**PINE SPRING FARM SUBDIVISION,  
RE-SUBDIVISION OF LOT 6, BLOCK C**

APPLICATION NUMBER 13 DATE June 16, 2011  
APPLICANT Pine Spring Farm Subdivision, Resubdivision of Lot 6, Block C  
REQUEST Subdivision

# DETAIL SITE PLAN

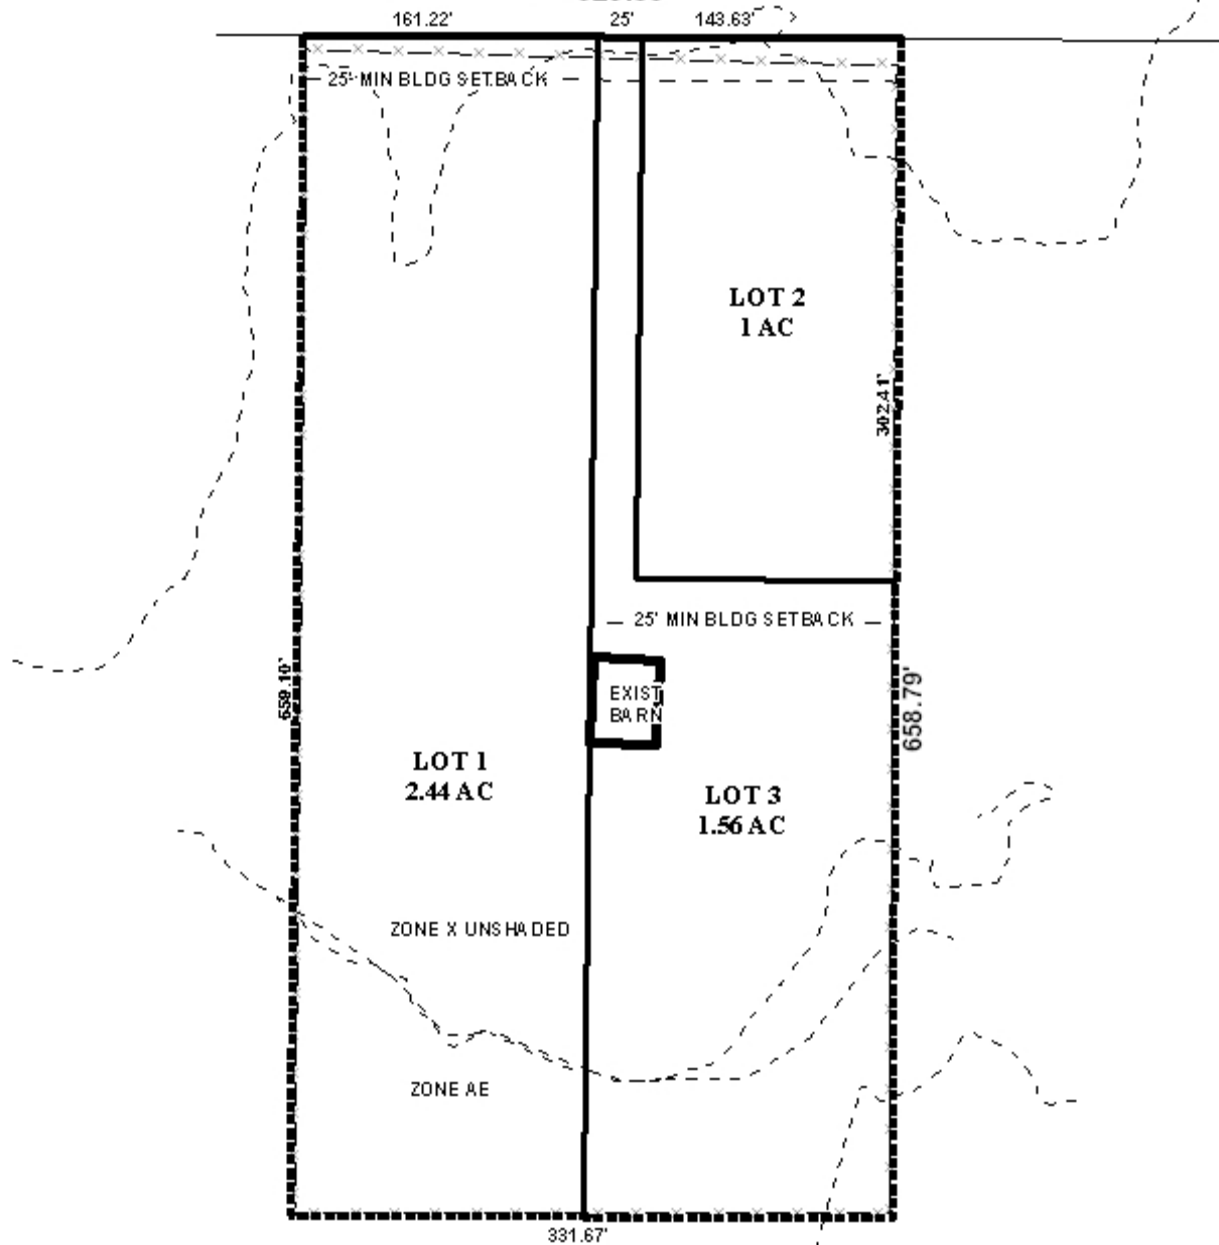
The applicant proposes that Lot 3 be a “flag” lot, with a 25 foot wide by 302.41'± long pole connecting the lot to Taylor Avenue. There are currently no other “flag” lots in the area.

As proposed, Lot 3 will be 1.56± acres in size, with a pole of 25-feet in width. If approved, future resubdivision of Lot 3 should be not be allowed until such time that additional frontage on a public street or compliant public/private street is provided.

It should also be noted that the proposed Lot 1 is 161'± wide at the building setback line and 659'± deep. Section V.D.3. of the Subdivision Regulations states that the maximum depth of any lots, exclusive of unusable land shall not be more than 3.5 times the width at the building setback line. Using this calculation, proposed Lot 1 is 95.5'± deeper than allowed.

The 25-foot minimum building setback line, required in Section V.D.9. of the Subdivision Regulations, is shown for the subdivision, and should be shown along all frontages, if approved. It should be noted that there is a barn on the proposed Lot 3, which appears to abut the proposed property line to Lot 1.

The lot sizes are labeled on the preliminary plat with the sizes in acres, but not square feet. If approved, both should be labeled on the Final Plat, if approved.

Based upon the preceding, the application is recommended for denial for the following reasons:

1. “flag” lots are not common in the area; and
2. no unusual circumstances or hardships exist which require the creation of a “flag” lot.
